TVA-SQN-TS-60

PROPOSED TECHNICAL SPECIFICATIONS

SEQUOYAH NUCLEAR PLANT
UNITS 1 AND 2

FIGURE 6.2-1
OFFSITE ORGANIZATION FOR FACILITY MANAGEMENT AND TECHNICAL SUPPORT

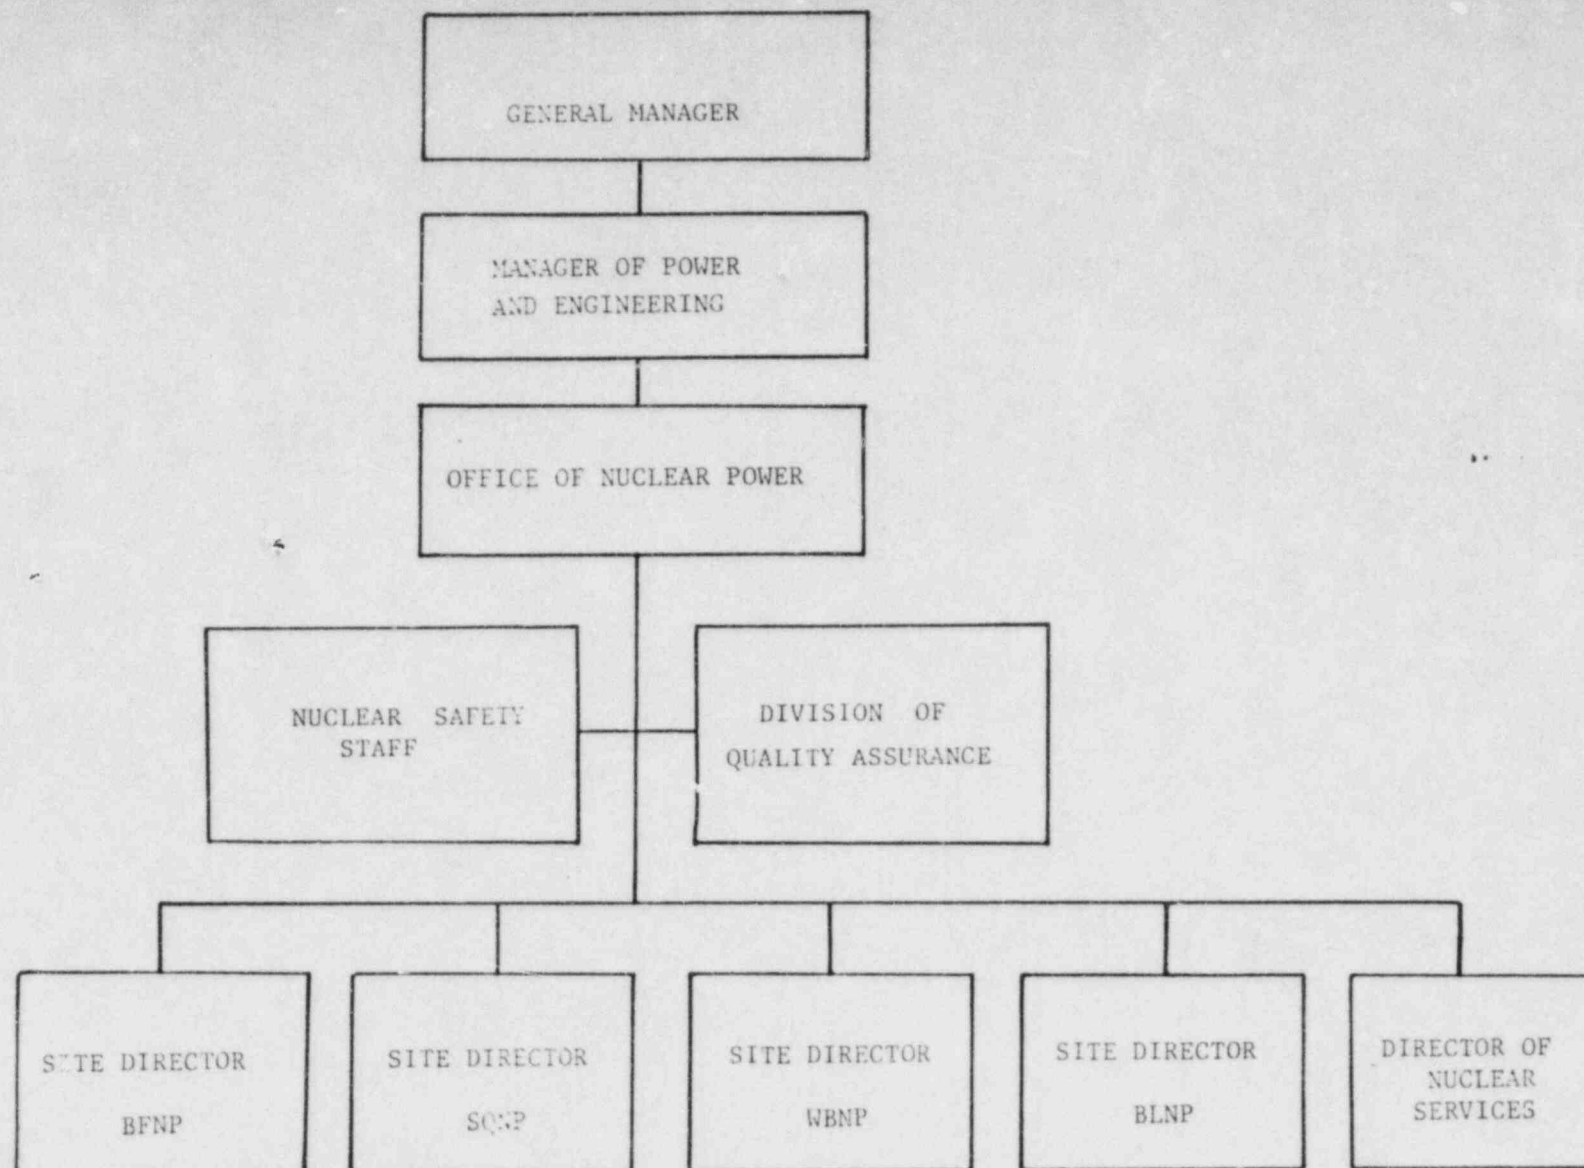
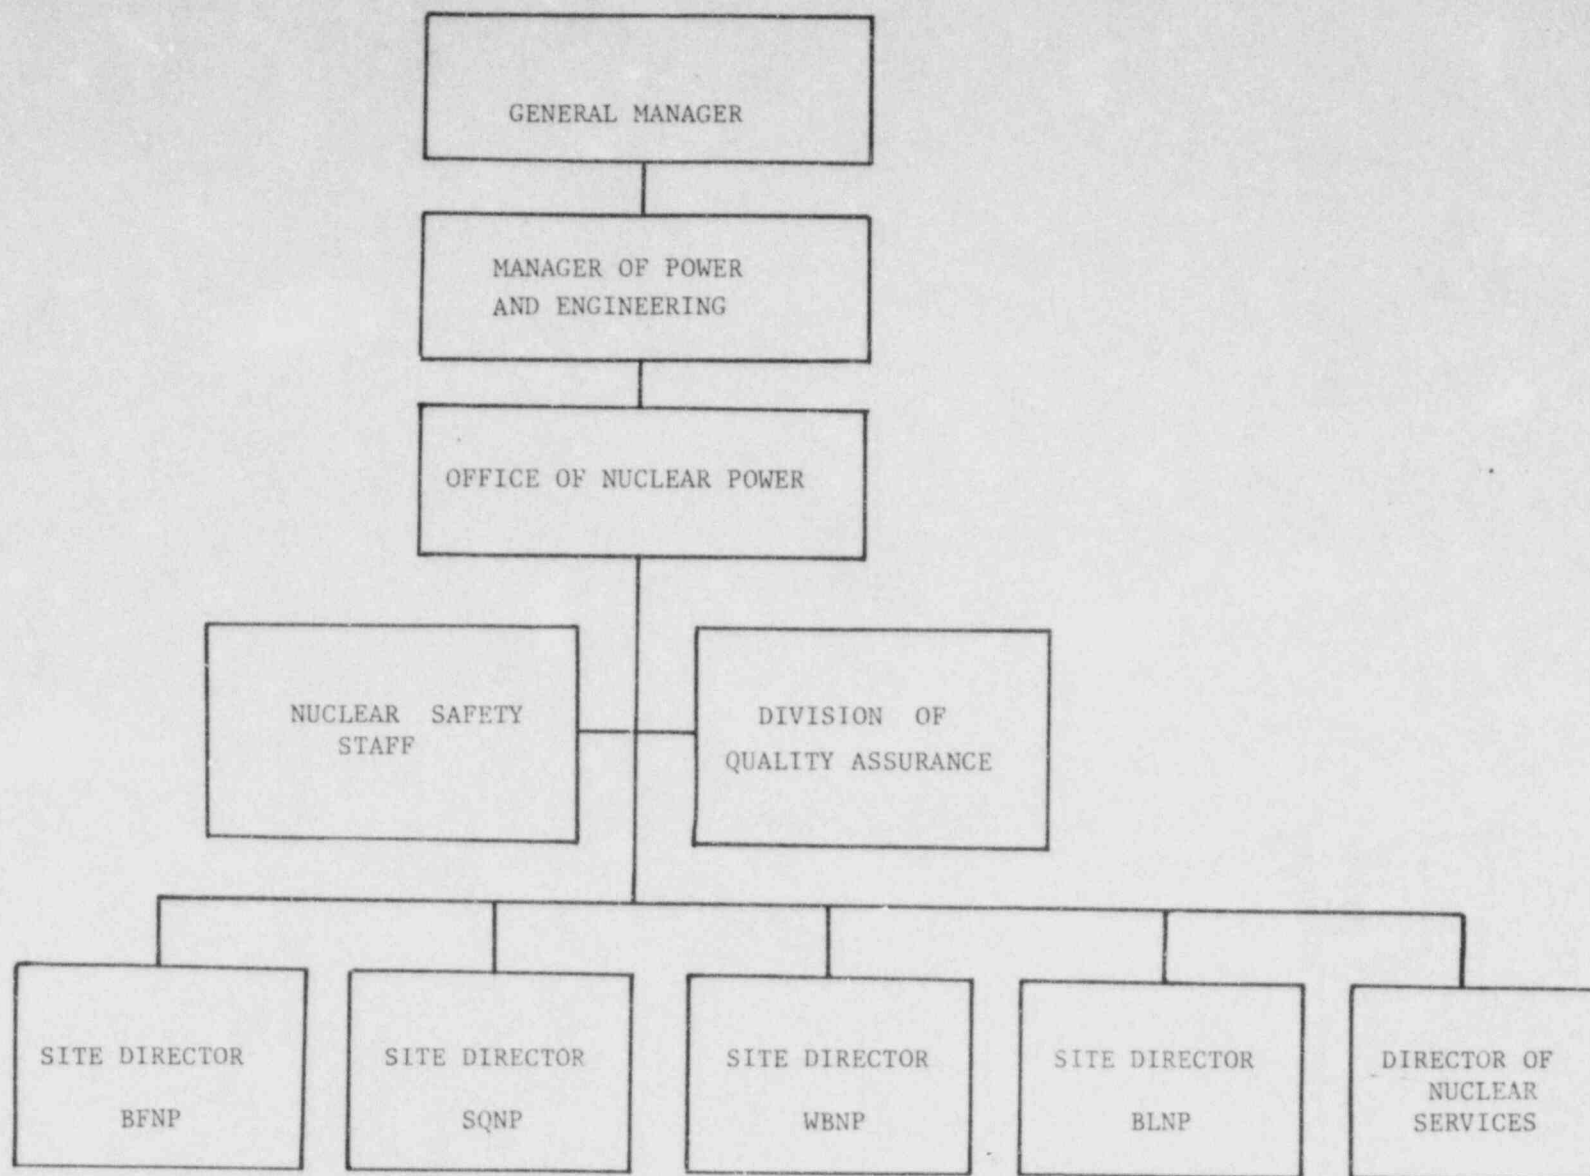
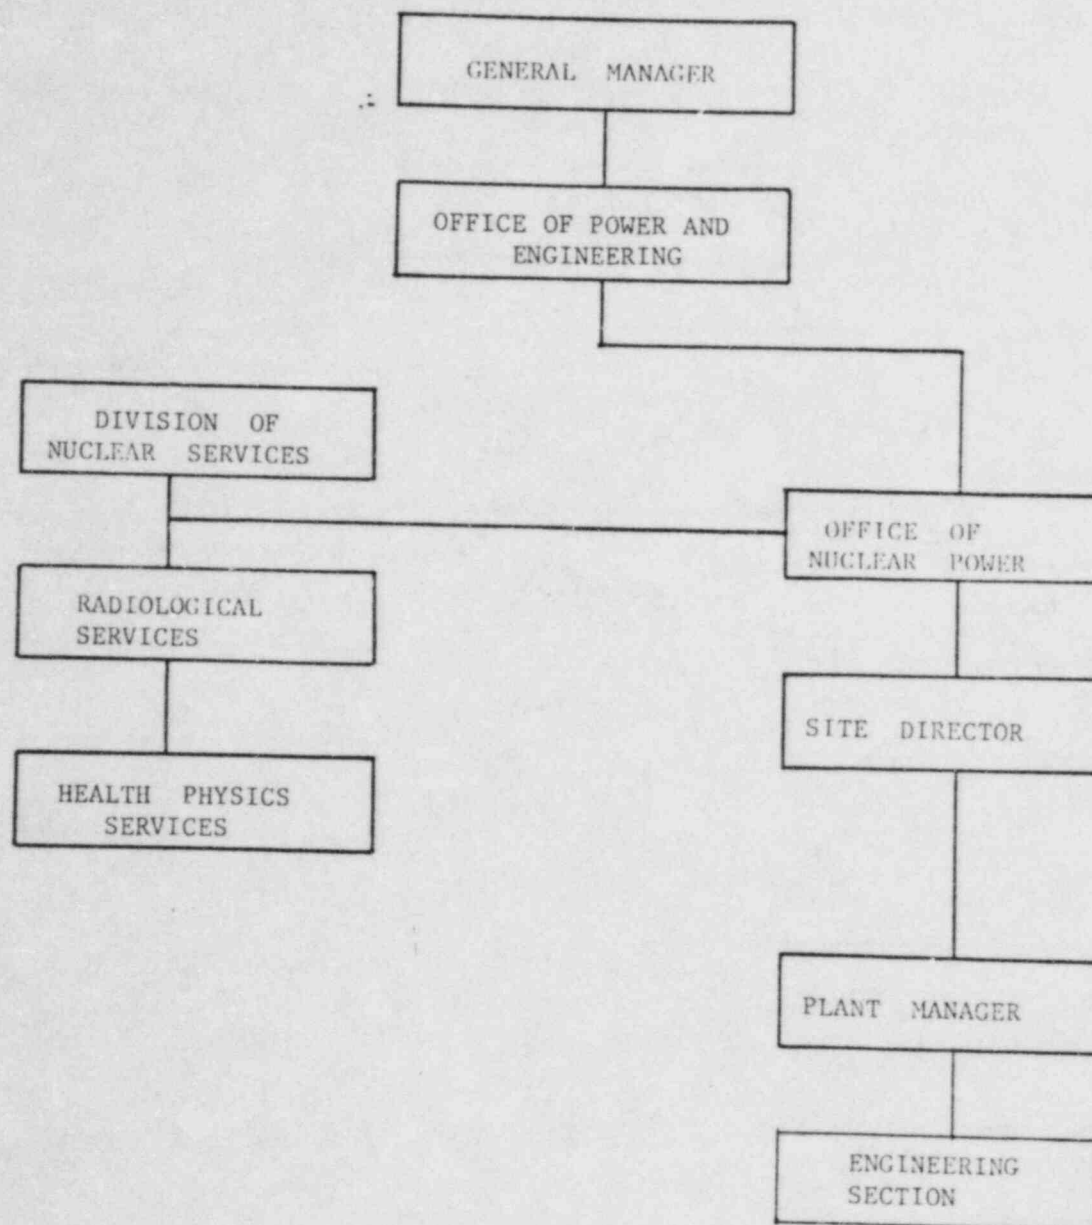
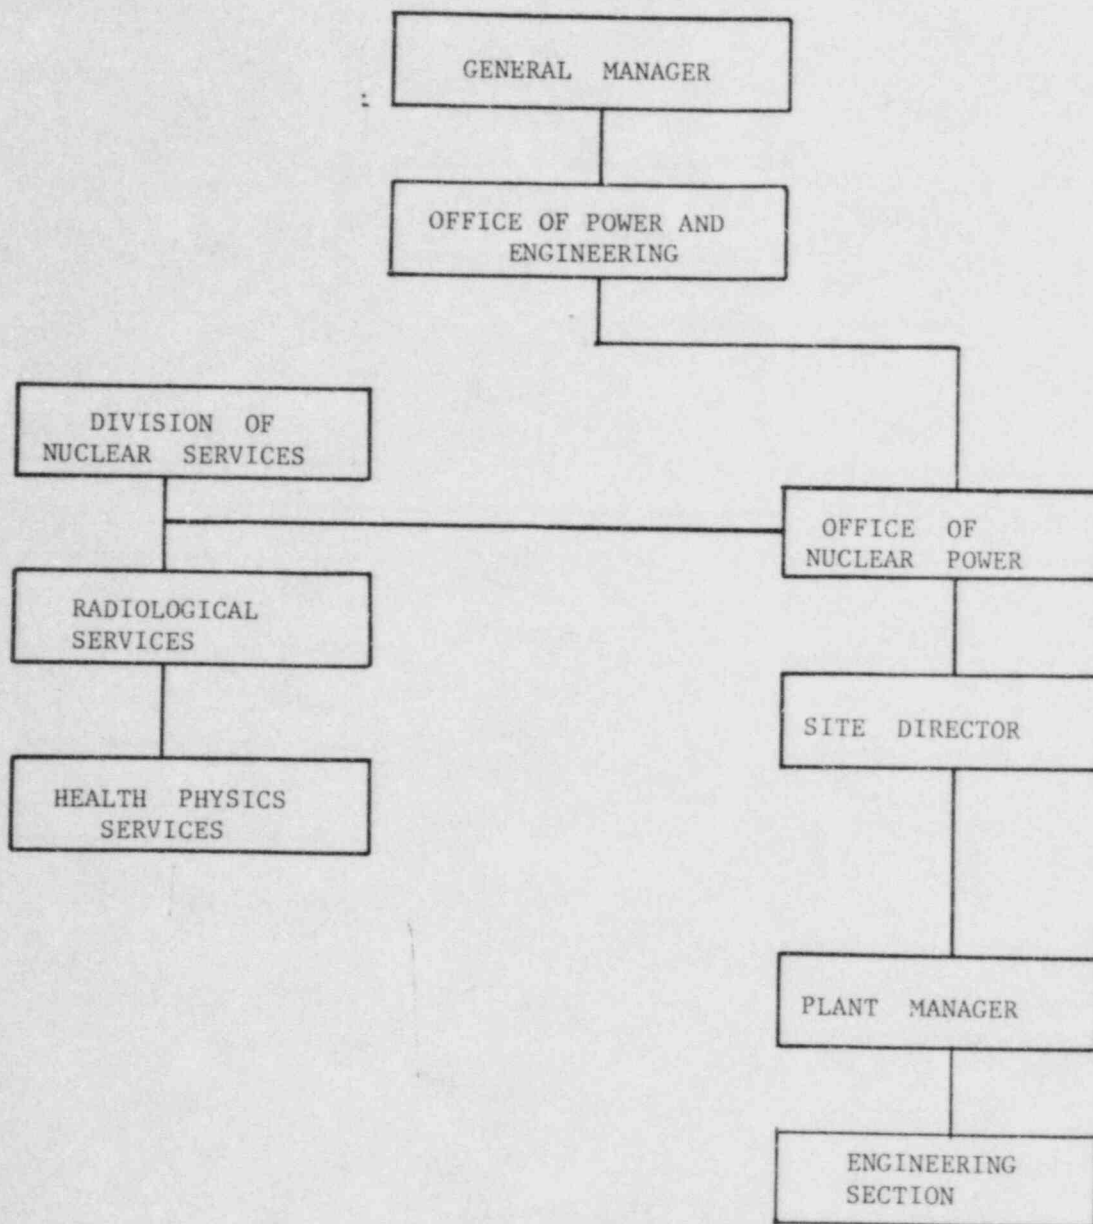
The plant organization shown in Figures 6.1-1, -2, and -3 have been changed to reflect the recent reorganization. This change does not directly impact safety. These changes are administrative only in nature.

The plant organization shown in Figures 6.1-1, -2, and -3 have been changed to reflect the recent reorganization. This change does not directly impact safety. These changes are administrative only in nature.

FIGURE 6.2-2
FACILITY ORGANIZATION

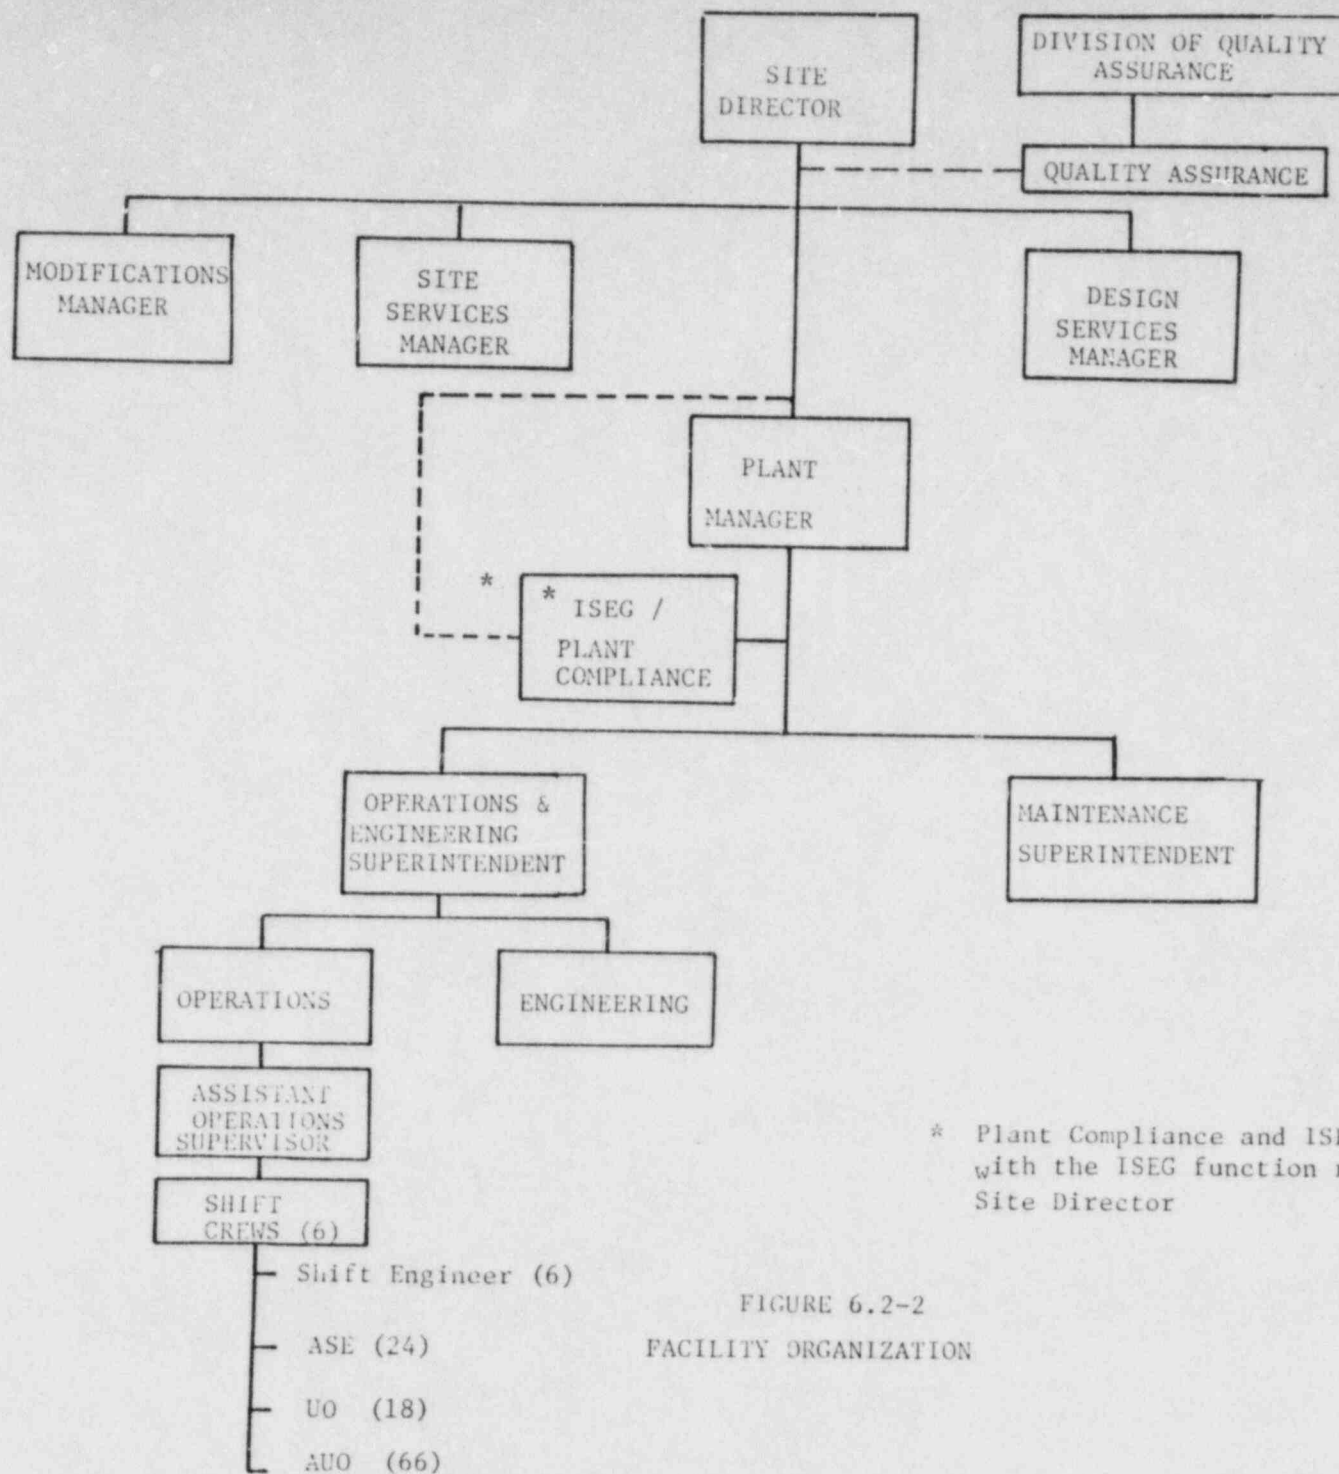
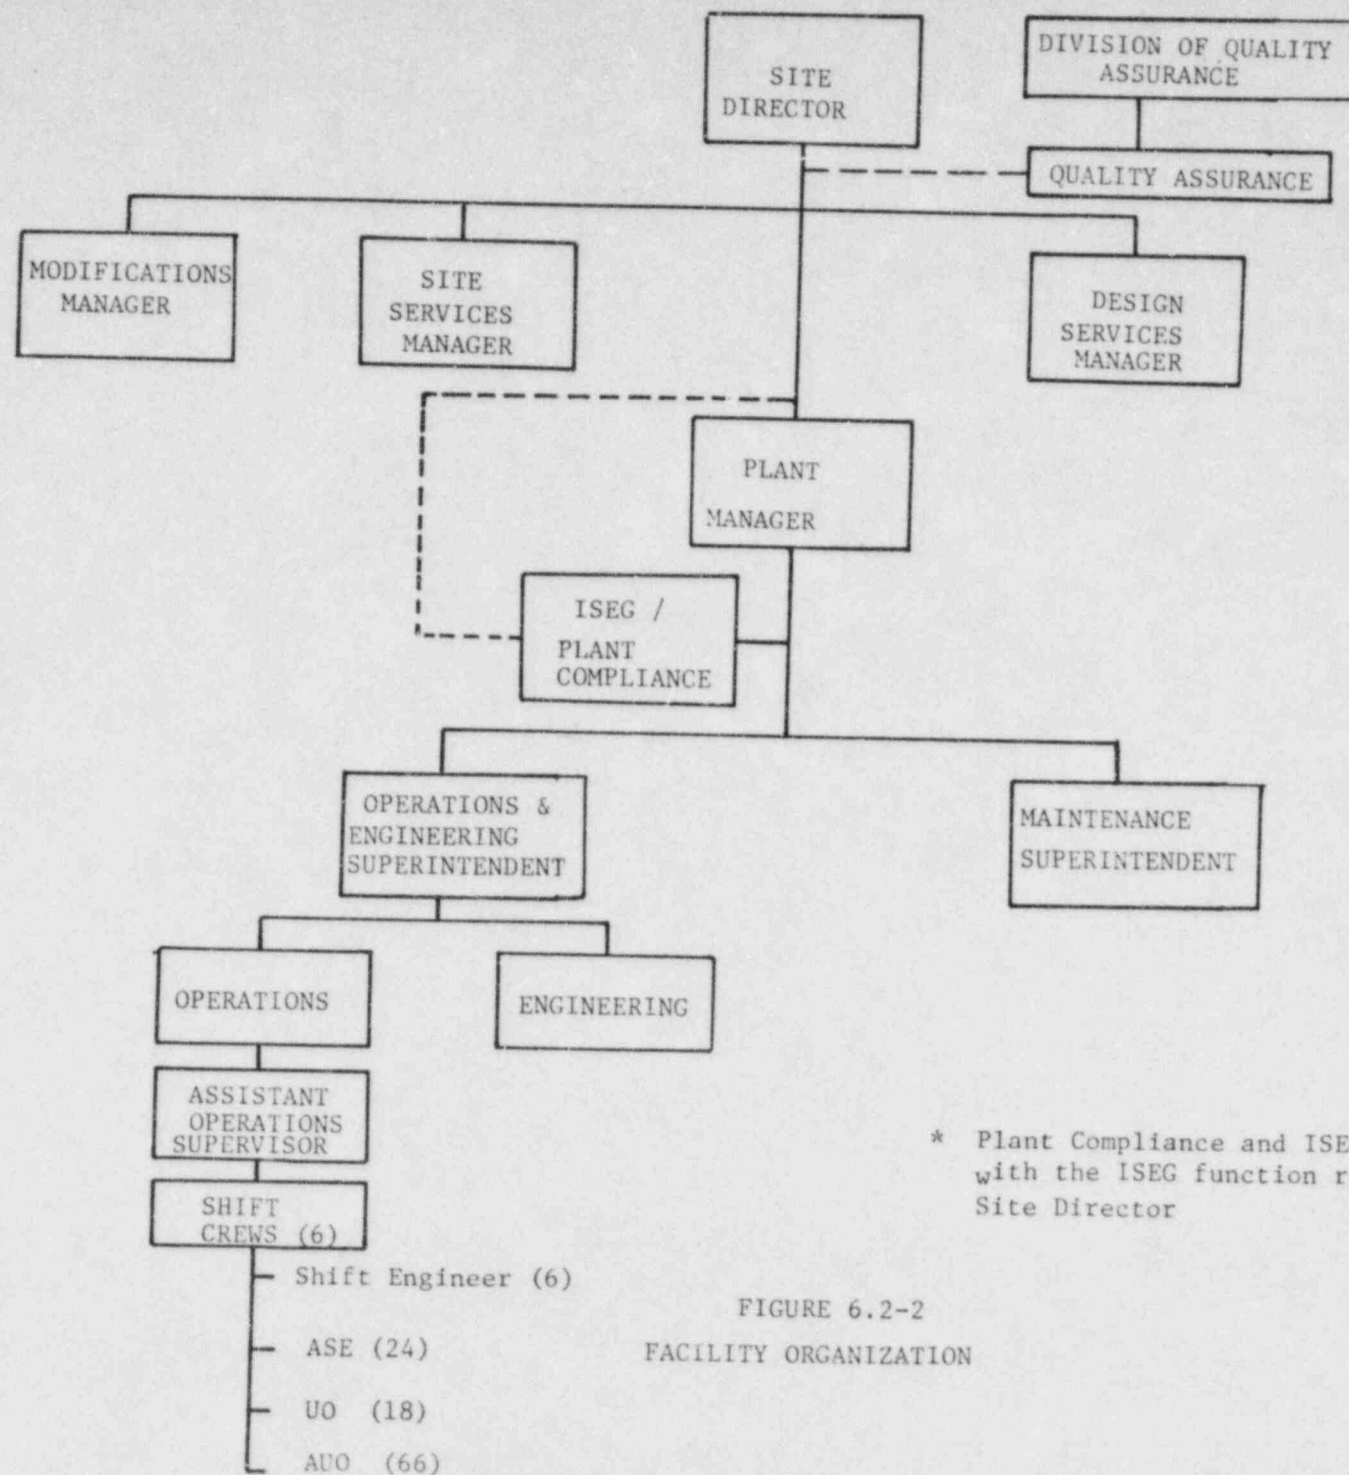
These changes are being requested to reflect the current status of the ISEG within the facility organization. Refer to revised figure 6.2-2. The ISEG will now report to the Site Director as a result of a recent TVA reorganization. Also a change is being requested to delete the term "dedicated" from 6.2.3.2.

These changes are being requested to reflect the current status of the ISEG within the facility organization. Refer to revised figure 6.2-2. The ISEG will now report to the Site Director as a result of a recent TVA reorganization. Also a change is being requested to delete the term "dedicated" from 6.2.3.2.
